PRIVATE SANITARY SEWER TO SERVE HAMILTON MIDDLE SCHOOL 1407 S BROADWAY 2182 PPS (607861) CITY OF WICHITA, KANSAS Gary Janzen, P.E., City Engineer

HAMILTON MIDDLE SCHOOL
 ADDITION
 U.S.D. 259
 1407 SOUTH BROADWAY ST., WICHITA, KANSAS 67211

AS BUILTS

12 February 2014
2182 PPS
Plan and
Profile

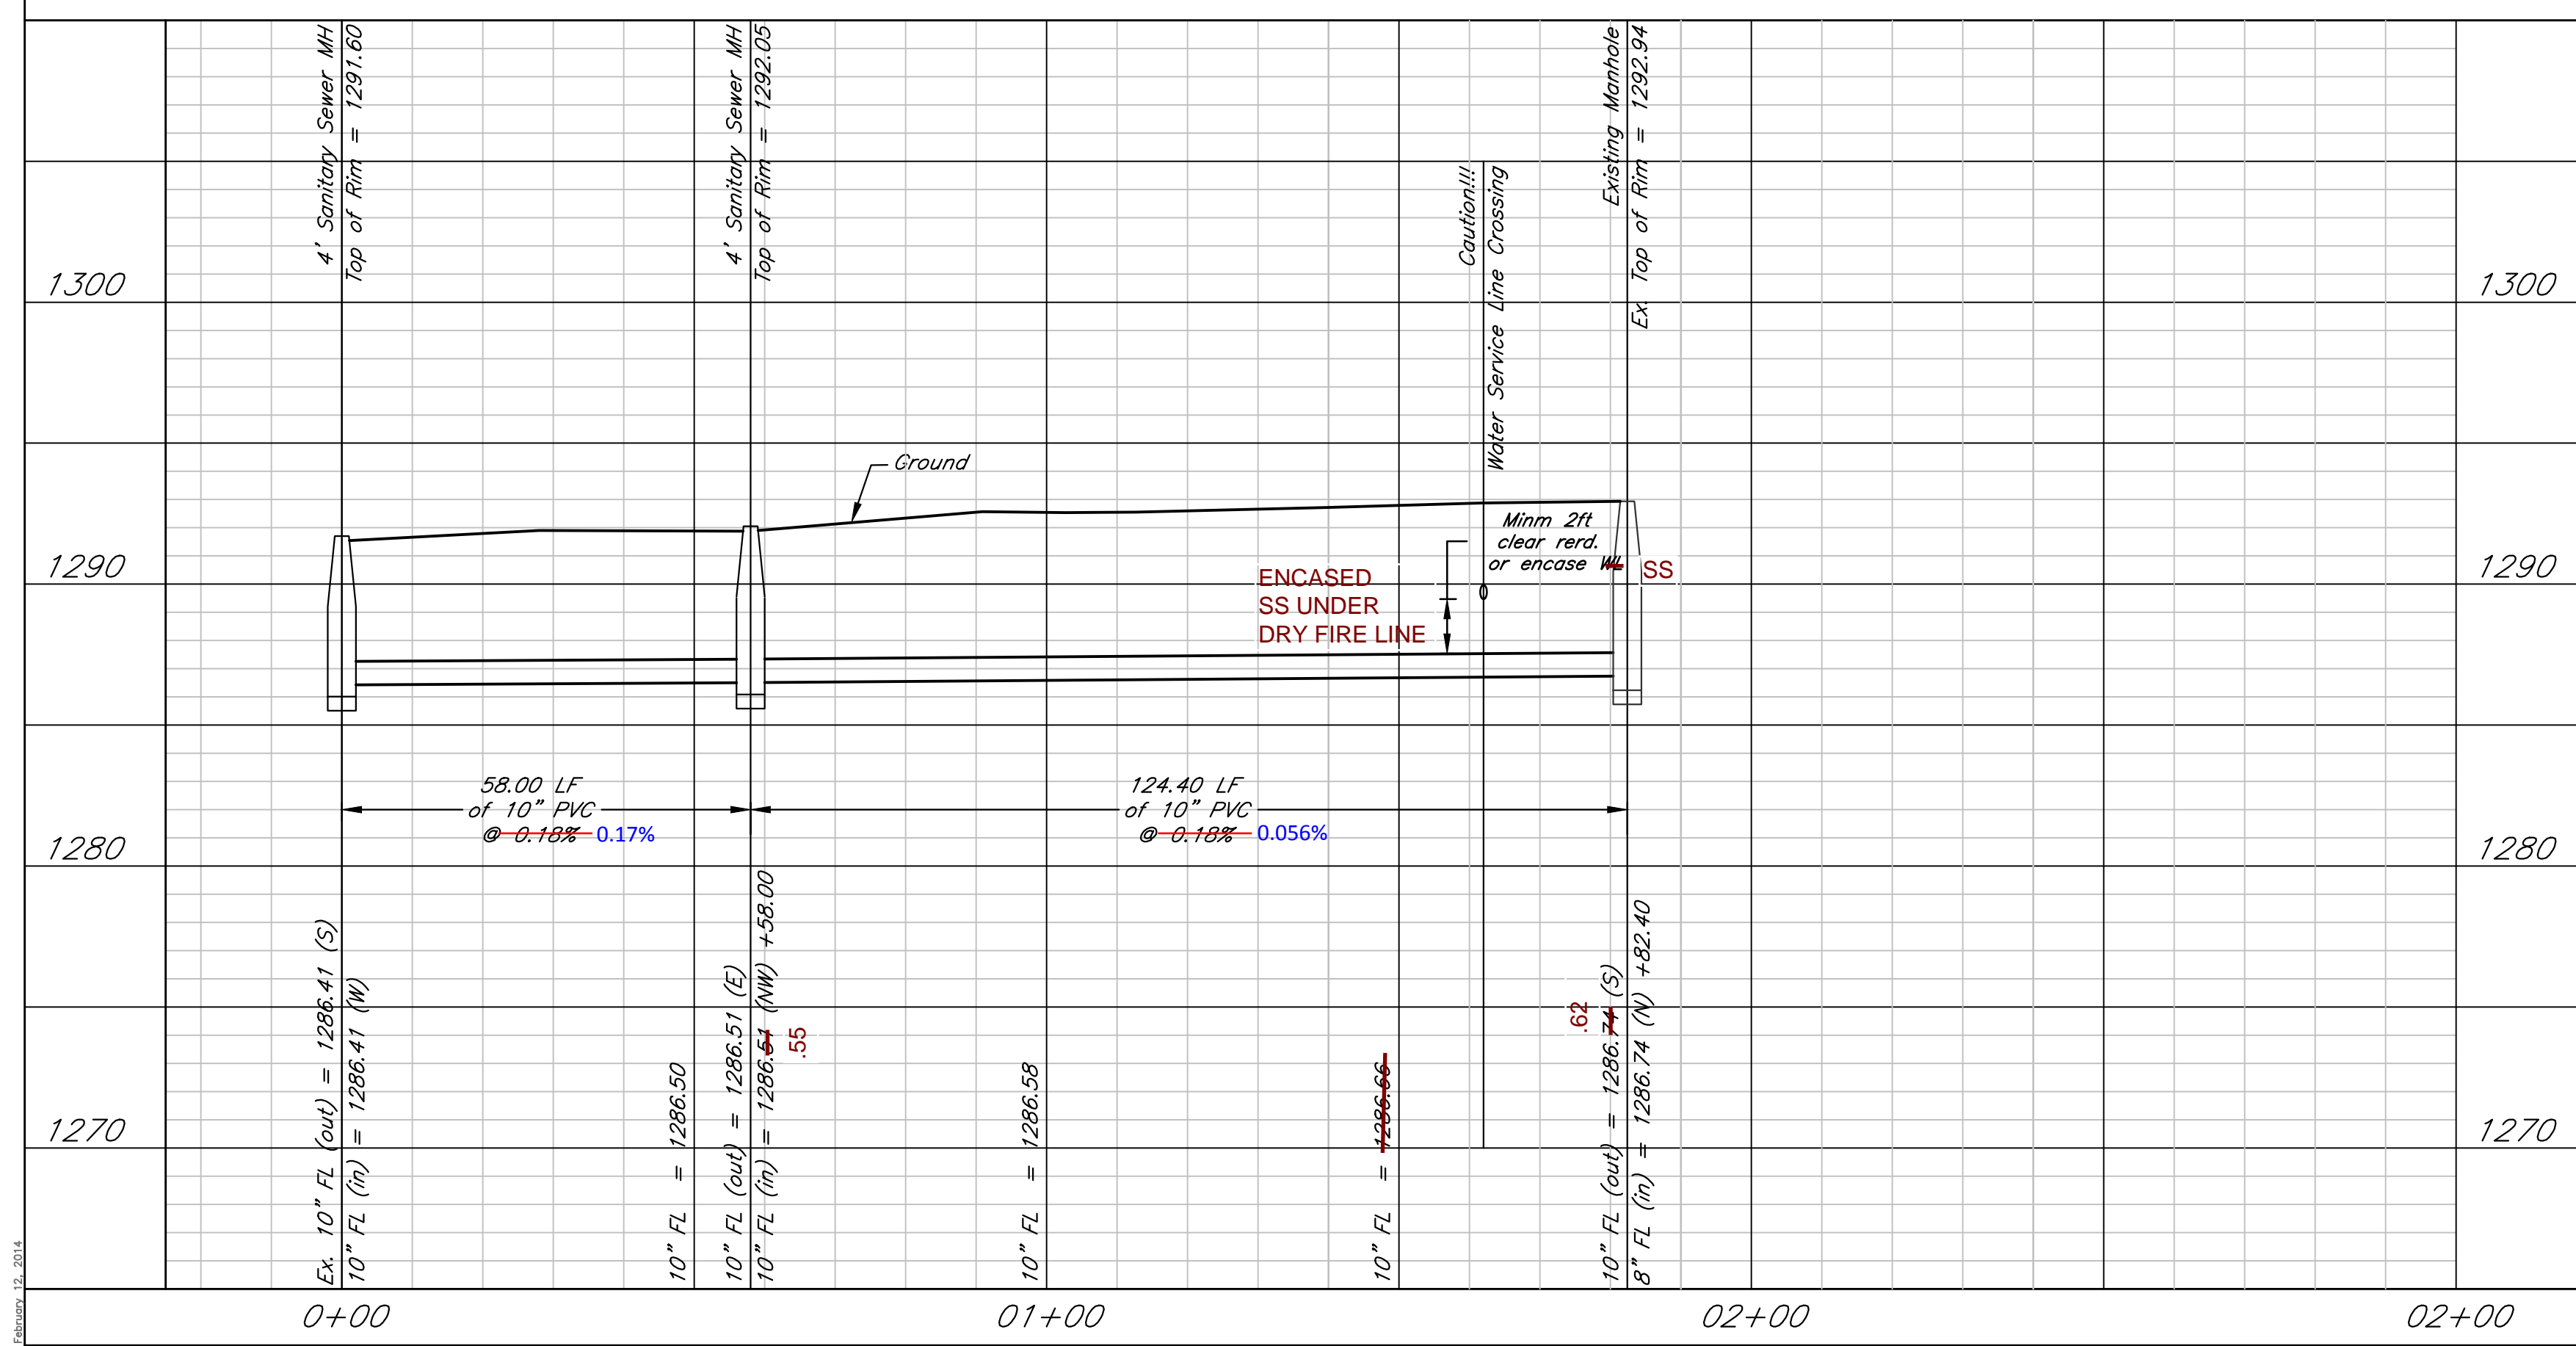
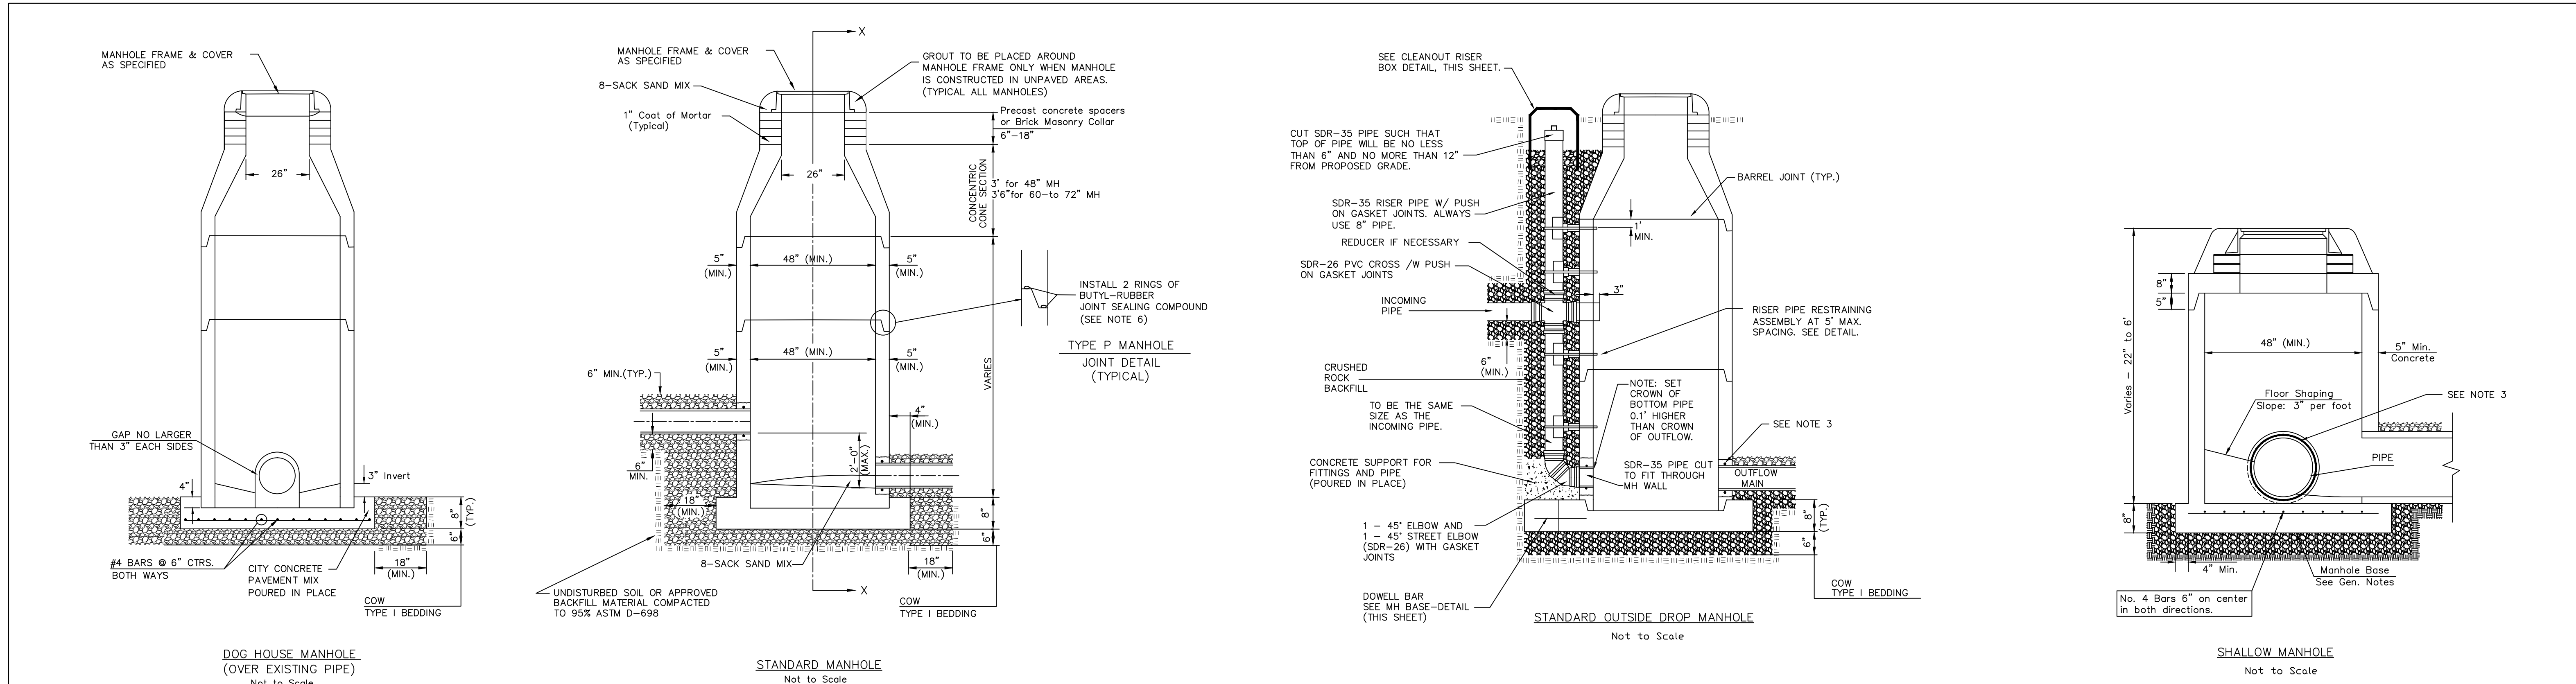
removed all of old existing ss lines and manhole

ENCASED SS 20"
